COUNCIL ASSESSMENT REPORT

Panel Reference	2018SNH065
DA Number	368/18
LGA	North Sydney
Proposed Development	Construction of a 48 storey hotel and office building
Street Address	86-88 Walker Street North Sydney
Applicant/Owner	Saul Moran/88 Walker Street Investments Pty Ltd; MRAKA Pty Ltd
Date of DA lodgement	6 November 2018
Number of Submissions	Two
Recommendation	Approval
Regional Development Criteria (Schedule 4A of the EP&A Act)	Capital Investment Value (CIV) of greater than \$30 million
List of all relevant s4.55(1)(a) matters	North Sydney LEP 2013 <ul style="list-style-type: none"> • Zoning – B3 Commercial Core SEPP 55 - Contaminated Lands SREP (Sydney Harbour Catchment) 2005 North Sydney DCP 2013
List all documents submitted with this report for the Panel's consideration	Conditions Plans Clause 4.6 request Design Statement
Report prepared by	Geoff Mossemeneer, Executive Planner North Sydney Council
Report date	16 January 2019

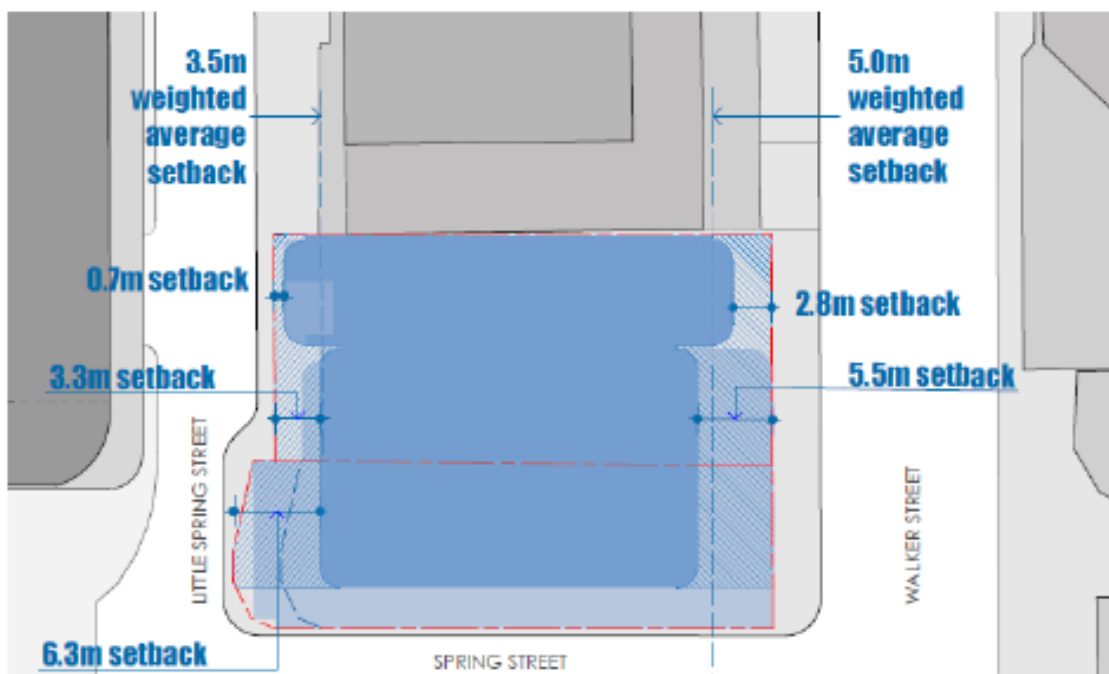
The podium setbacks to Spring Street (3m) and Little Spring Street (3.5m) are not compliant with the DCP control of 4m.

- The setback survey demonstrates that there is no pattern with regards to the setbacks of adjacent buildings on both Spring Street and Little Walker Street that adhering to the DCP setbacks will enhance.

- The setbacks of the tower as a cantilevered element above the Firehouse Hotel are well proportioned, maintain views to the sky and do not result in a form that dominates the streetscape.

Building Signage Facing North

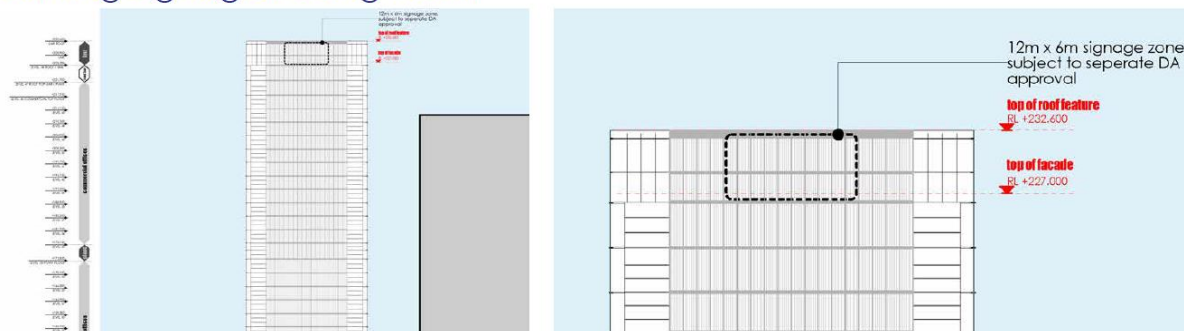
Under Section 9 of the DCP, Roof or sky signs are generally not permitted. However, Council may consider new roof or sky signage, but only where:

- The new signs replace one or more existing roof or sky signs and improve the visual amenity of the locality; or
- The new signs improve the finish and appearance of the building and the streetscape

Roof or sky signs will only be permitted if they are associated with a non-residential use in the B3 – Commercial Core or B4 – Mixed Use zones.

Roof or sky signs must not be positioned higher than the highest point of any part of the building, including lift overruns or air conditioning plants but excluding flag poles, aerals, masts and the like.
